UNITED STATES PATENT AND TRADEMARK OFFICE

APPLICATION NO.	FILING DATE	FIRST NAMED INVENTOR	ATTORNEY DOCKET NO.	CONFIRMATION NO.
09/765,014	01/17/2001	Oscar E. Agazzi	36976/NJP/B600	7258
7590 10/18/2005 CHRISTOPHER C. WINSLADE MCANDREWS, HELD & MALLOY 500 W. MADISON STREET SUITE 3400 CHICAGO, IL 60661			EXAMINER KIM, DAVID S	
			ART UNIT 2633	PAPER NUMBER
DATE MAILED: 10/18/2005

Office Action Summary

TITLE: High Speed Transmission System for Optical Channels
INVENTOR: Agazzi
APPLICATION NO.: 09/765,014,
CONF. NO. 7258; DOCKET NO. 13445US02
ATTORNEY: JAW, PHONE: 312-775-8000
Replacement Figure 6

FIG. 5

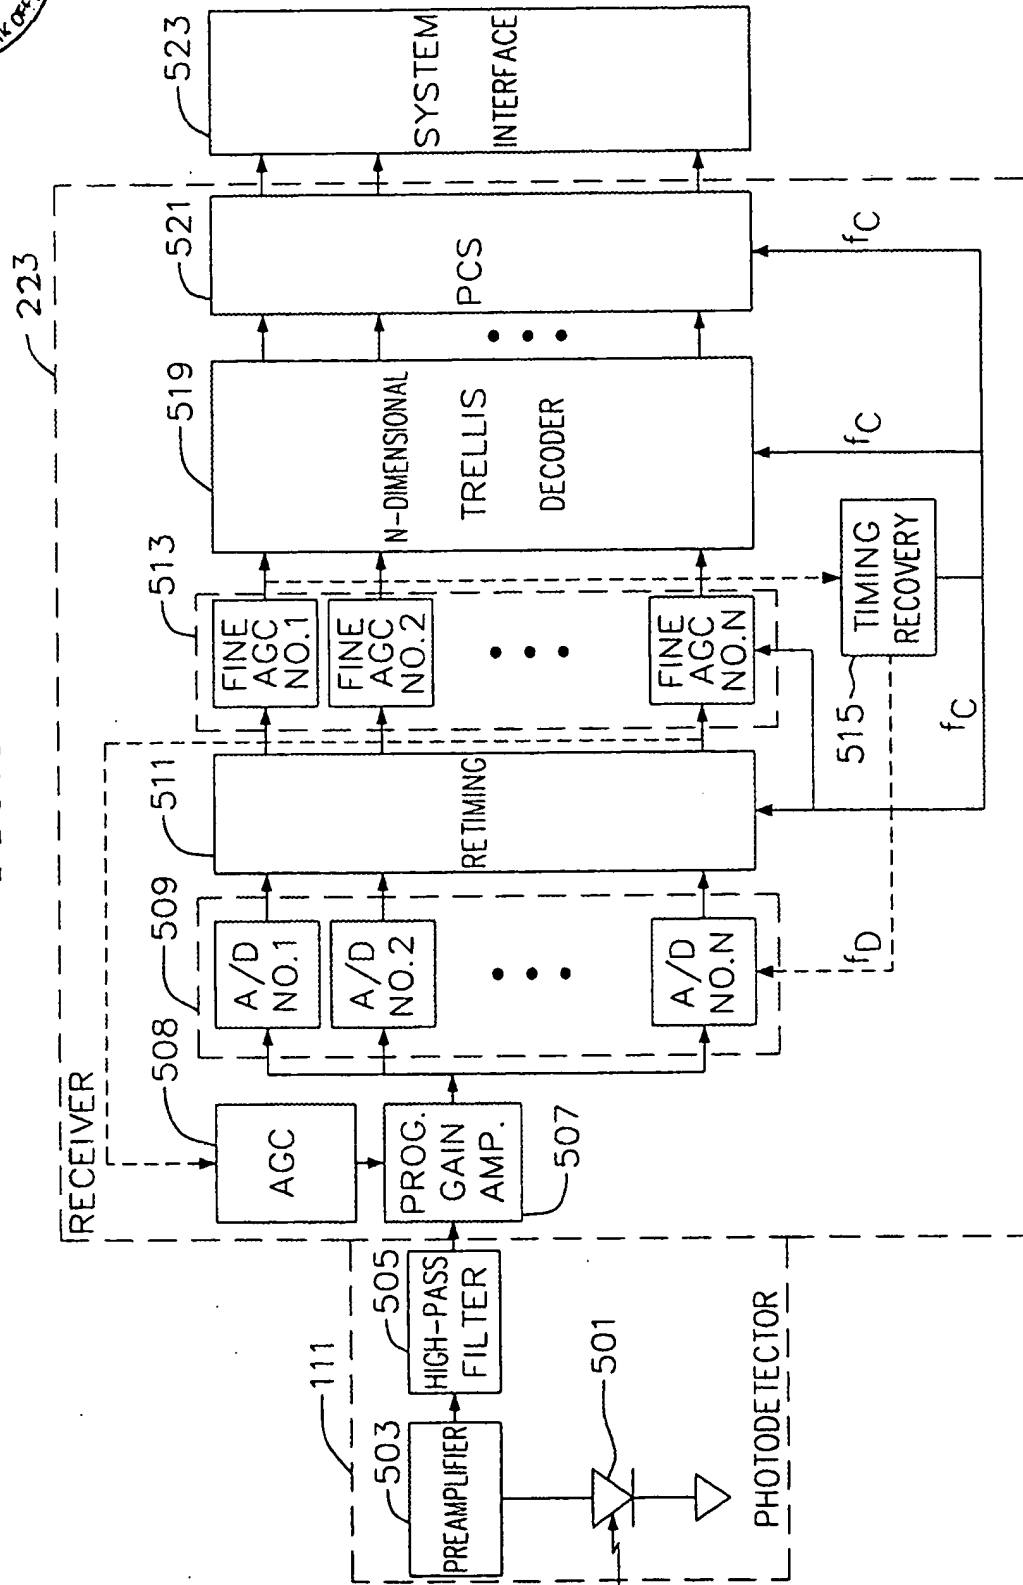
Fig. 5 is disapproved because reference character "111" is used where -- 215 -- may be intended.

Disapproved by DSK
05 OCTOBER 2008
